APPLICATION NO.	FILING DATE	FIRST NAMED INVENTOR	ATTORNEY DOCKET NO.	CONFIRMATION NO.
10/621,317	07/18/2003	Ashvin D. Desai	87344.1524	2539

Office Action Summary

- 1) ☒ Responsive to communication(s) filed on 14 February 2005.
- 2a) ☒ This action is **FINAL**. 2b) ☐ This action is non-final.
- 3) ☐ Since this application is in condition for allowance except for formal matters, prosecution as to the merits is closed in accordance with the practice under *Ex parte Quayle*, 1935 C.D. 11, 453 O.G. 213.

FIG. 2

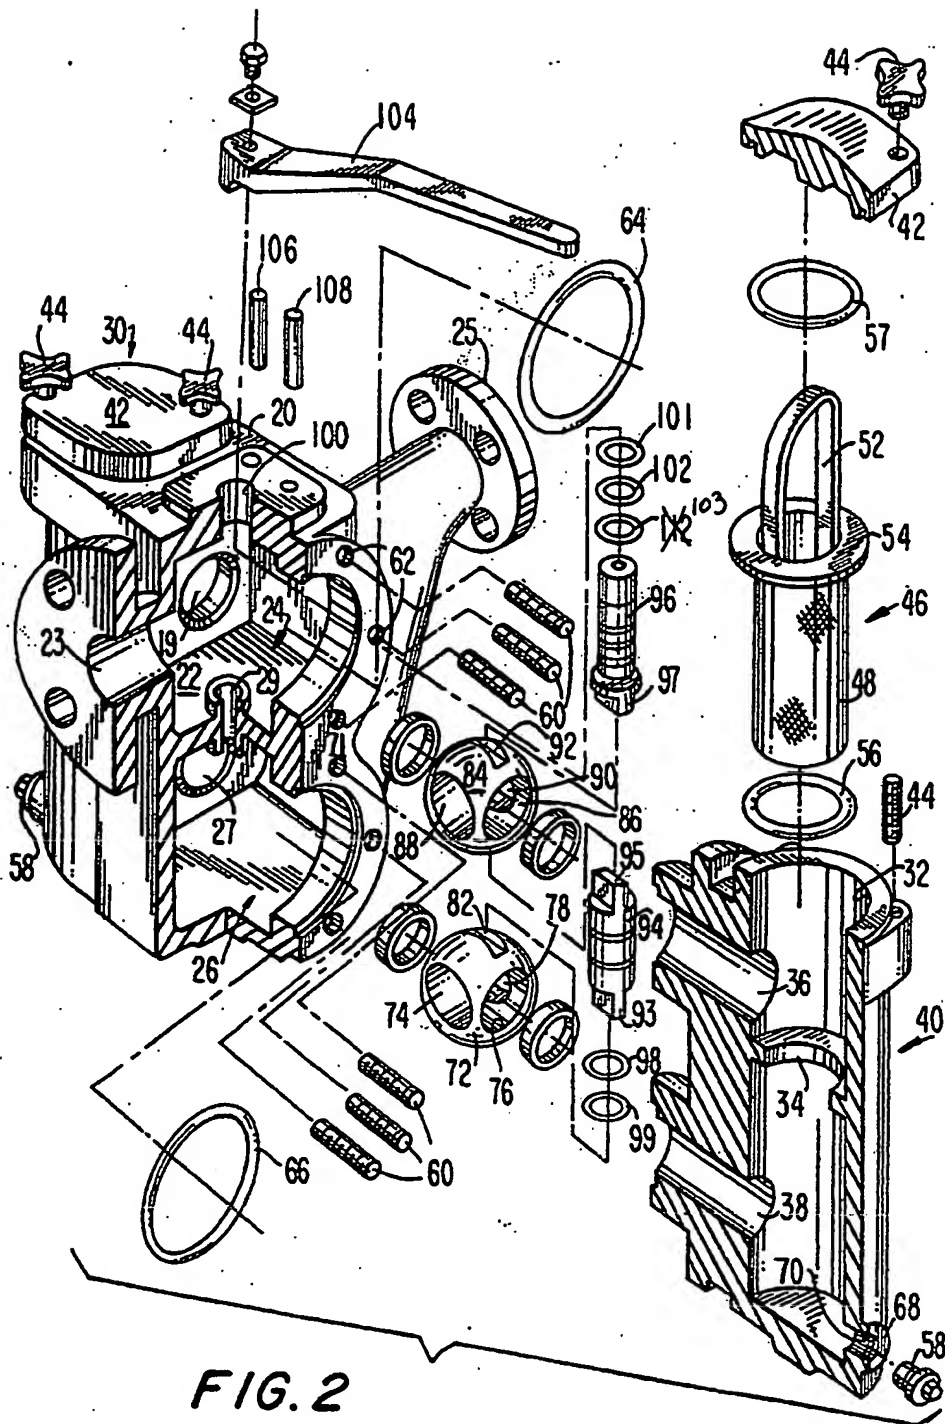
The drawing corrections to FIGS. 2-3 filed on 2-14-05 have been approved.

Okay to enter.
mg

FIG. 3

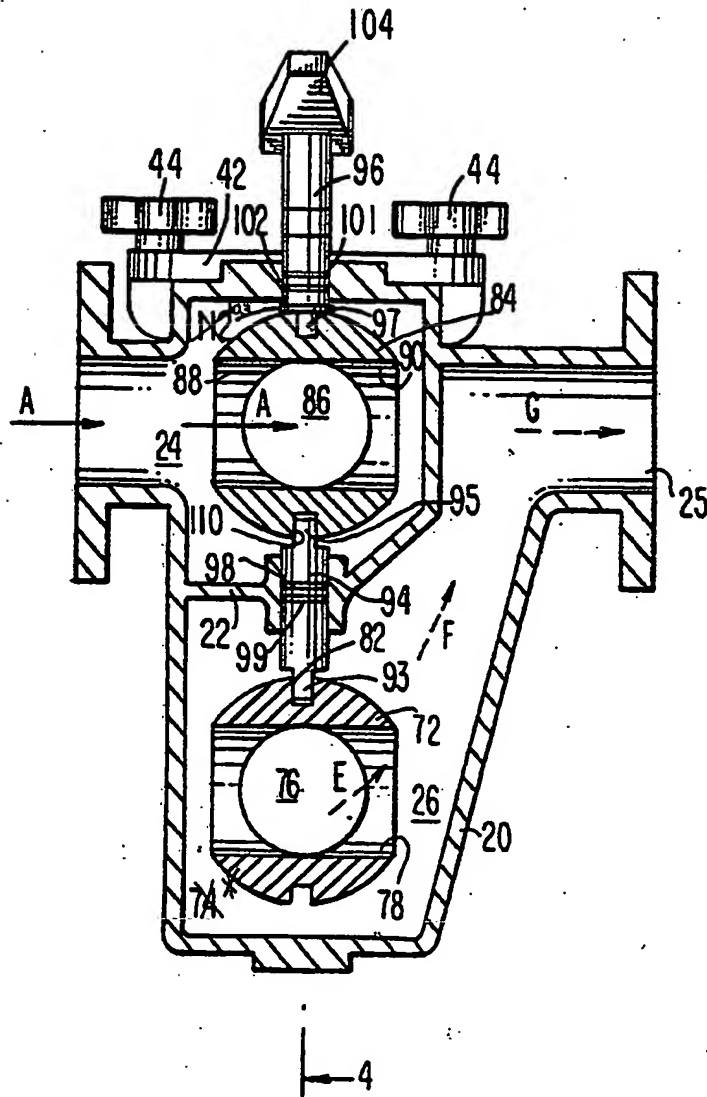
Okay to submit
ms

FIG. 4

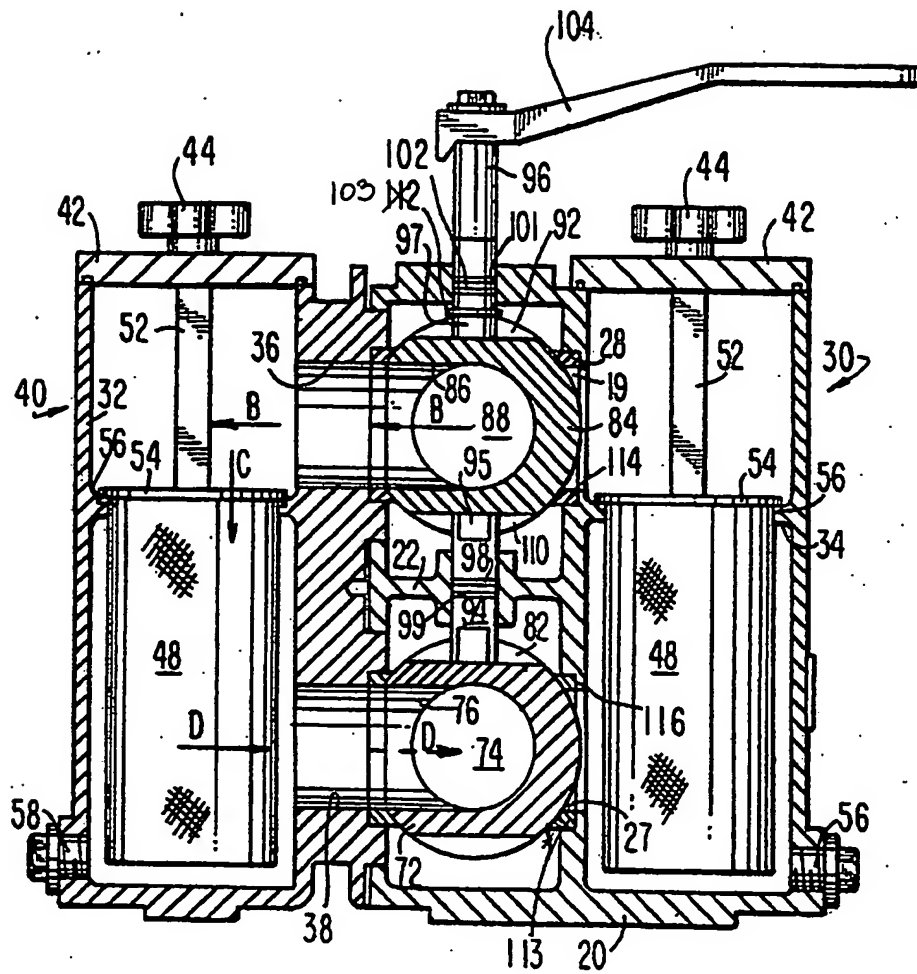
The drawing corrections to FIG. 4 has not been approved for the reasons set forth below.

The lead line for element 28 is incorrect in FIG. 4 (the lead line should be redrawn so that it points out the seat adjacent the entry port 36);

The lead line for element 116 is incorrect in FIG. 4 (the lead line should be redrawn so as to point out the seat adjacent exit port 38).

Do not enter.
ms

A proposed drawing correction or corrected drawings are required in reply to the Office action to avoid abandonment of the application. The objection to the drawings will not be held in abeyance.
